# City of Hamilton Proposed Waste Design Guidelines

WE HBA Comments and Concerns – November 1<sup>st</sup>, 2021

1430 Main St.

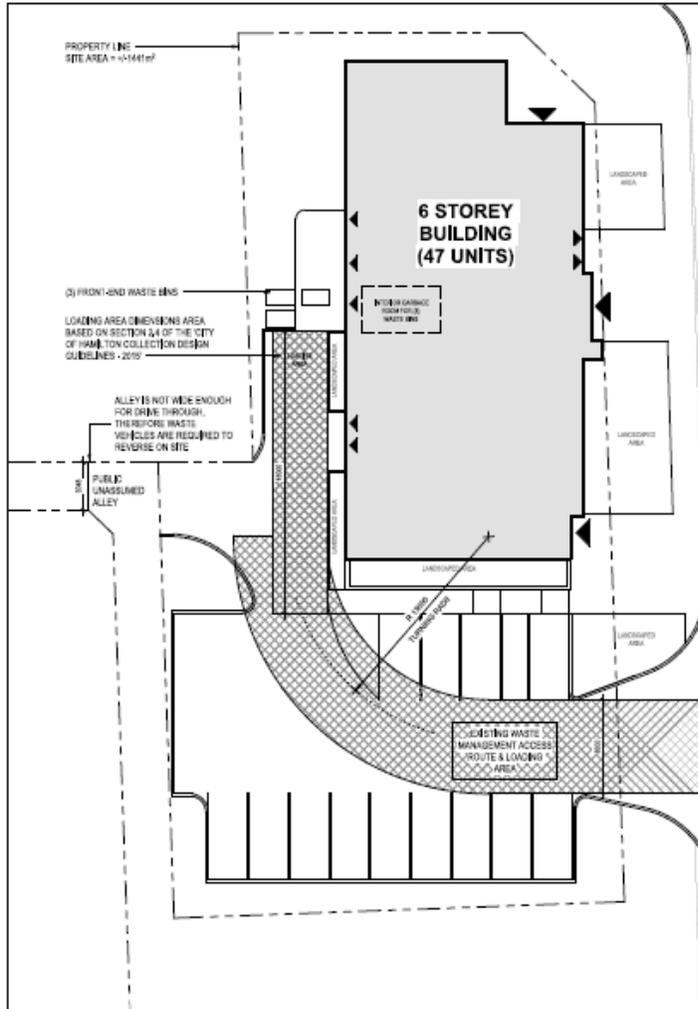
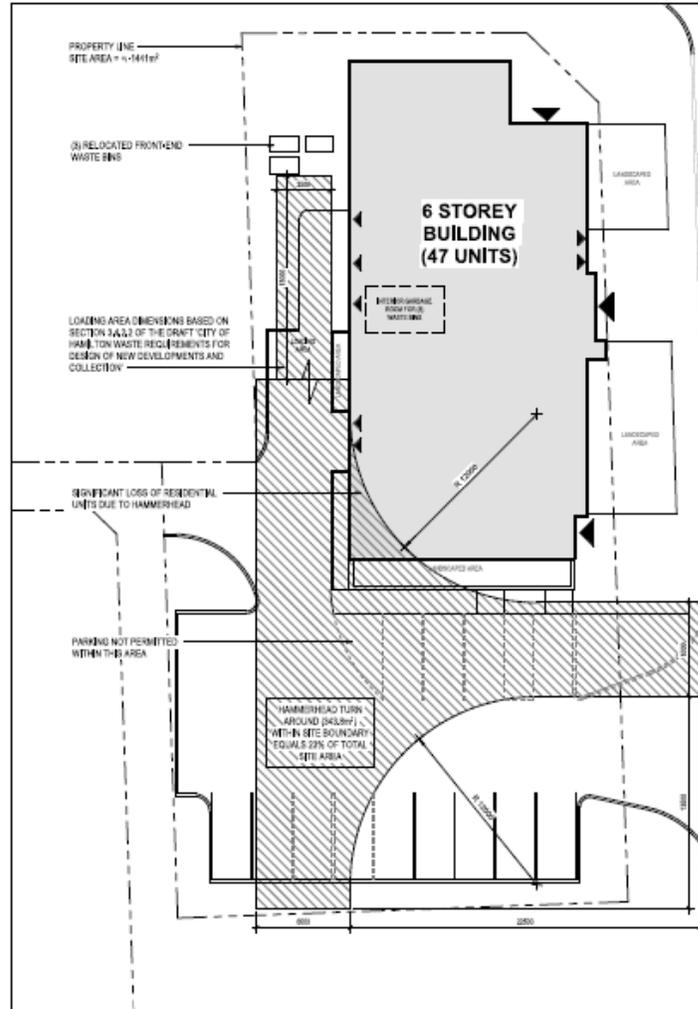
- 6 STOREYS = SMALL MULTIRESIDENTIAL BUILDING
- FRONT END LOADING FOR GARAGE
- (2) WASTE BINS (5 m<sup>2</sup> STORAGE EACH) BASED ON TABLE 7: NUMBER OF GARAGE CONTAINERS FOR MULTIRESIDENTIAL BUILDINGS\*
- (3) X (5m<sup>2</sup>) = 15m<sup>2</sup> INTERIOR STORAGE SPACE

- SIGNIFICANT LOSS OF PARKING DUE TO HAMMERHEAD SPACE REQUIREMENTS (7 SPACES LOST)
- REDUCTION OF BUILDING AREA AND RESIDENTIAL UNITS DUE TO HAMMERHEAD SPACE REQUIREMENTS (MIN. 6 UNITS LOST)
- LOADING AREA IMPEDES EXITING AND EGRESS AT THE REAR OF THE BUILDING
- GOALS FOR INTENSIFICATION WOULD BE REDUCED DUE TO PROPOSED HAMMERHEAD REQUIREMENTS

**TOTAL LOSSES:**

47 UNITS IS REDUCED BY 6 TO 41 UNITS BASED ON BUILDING AREA CLEAR OF HAMMERHEAD

13 PARKING SPACES IS REDUCED TO 7

REDUCTION OF PARKING MEANS FURTHER REDUCTION OF UNITS (BASED ON SECTION 5.6 OF BY-LAW 95-200 ASSUMING UNITS AS >50m<sup>2</sup>, AT 6.5 PER UNIT A FURTHER REDUCTION OF 14 UNITS OCCURS)

47 UNITS - 6 UNITS - 14 UNITS = 27 UNITS TOTAL
